<b>Well Name:</b> POKER LAKE UNIT 19 DTD	<b>Well Location:</b> T24S / R30E / SEC 19 / NWNE /	<b>County or Parish/State:</b>
<b>Well Number:</b> 409H	<b>Type of Well:</b> OIL WELL	<b>Allottee or Tribe Name:</b>
<b>Lease Number:</b> NMNM002860	<b>Unit or CA Name:</b>	<b>Unit or CA Number:</b> NMNM07016Z
<b>US Well Number:</b> 3001553984	<b>Well Status:</b> Approved Application for Permit to Drill	<b>Operator:</b> XTO PERMIAN OPERATING LLC

**Sundry ID: 2777318**

**Type of Action:** APD Change

**Procedure Description:** XTO Permian Operating, LLC. respectfully requests approval to make the following changes to the approved APD. Changes to include SHL, FTP, LTP, BHL, casing sizes, cement, proposed total depth, and formation (pool). FROM: TO: SHL: 196' FNL & 1656' FEL of Section 19-T24S-R30E 271' FNL & 1656' FEL of Section 19-T24S-R30E FTP: 100' FSL & 1530' FEL of Section 18-T24S-R30E 100' FNL & 1006' FEL of Section 19-T24S-R30E LTP: 2310' FSL & 1530' FEL of Section 31-T23S-R30E 330' FSL & 1019' FEL of Section 31-T25S-R30E BHL: 2440' FSL & 1530' FEL of Section 31-T23S-R30E 230' FSL & 1019' FEL of Section 31-T25S-R30E Proposed total depth will change from 27888' MD; 9331' TVD (Bone Spr

*Note: Picture below highlights BOP components that will be tested during batch operations*

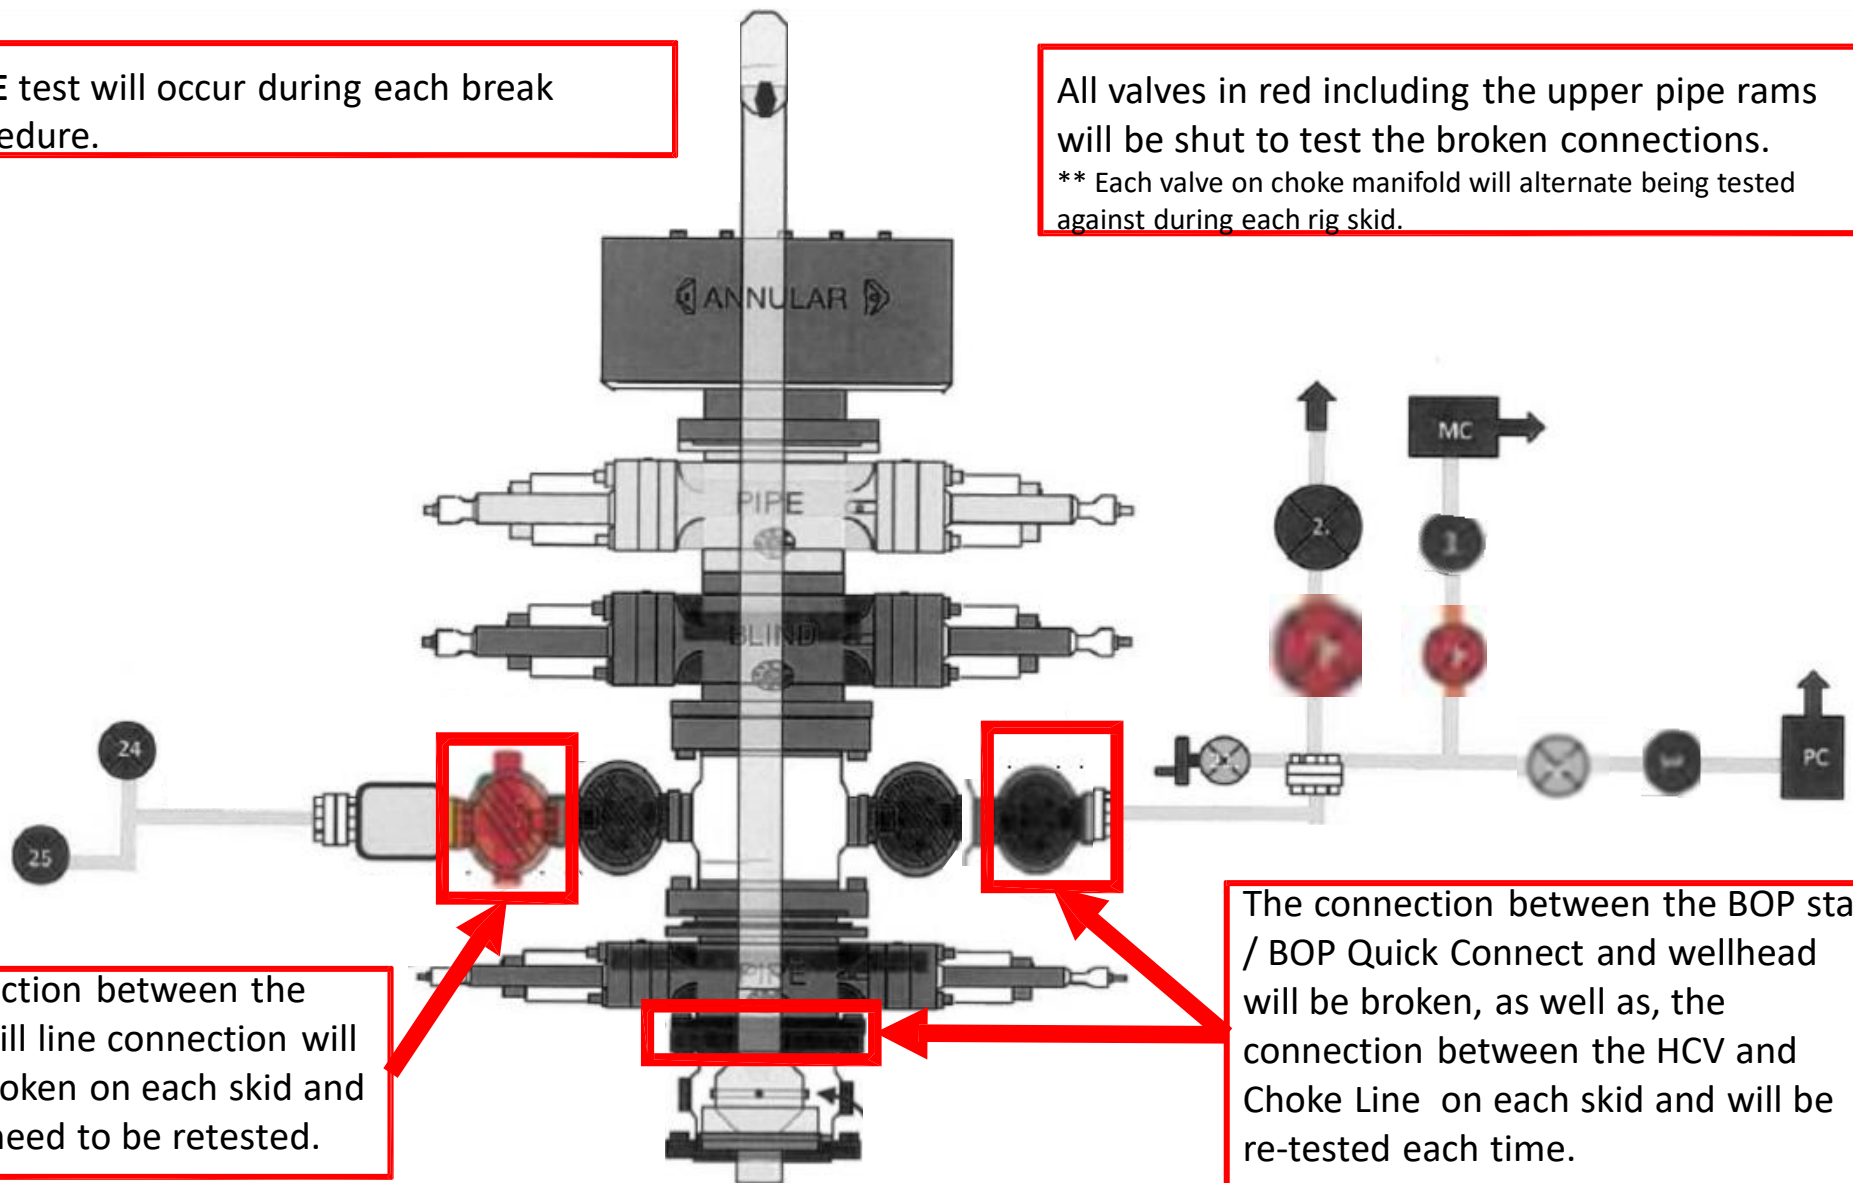
All valves in red including the upper pipe rams will be shut to test the broken connections.  
\*\* Each valve on choke manifold will alternate being tested against during each rig skid.

The connection between the HCV and kill line connection will **NOT** be broken on each skid and does not need to be retested.

The connection between the BOP stack / BOP Quick Connect and wellhead will be broken, as well as, the connection between the HCV and Choke Line on each skid and will be re-tested each time.
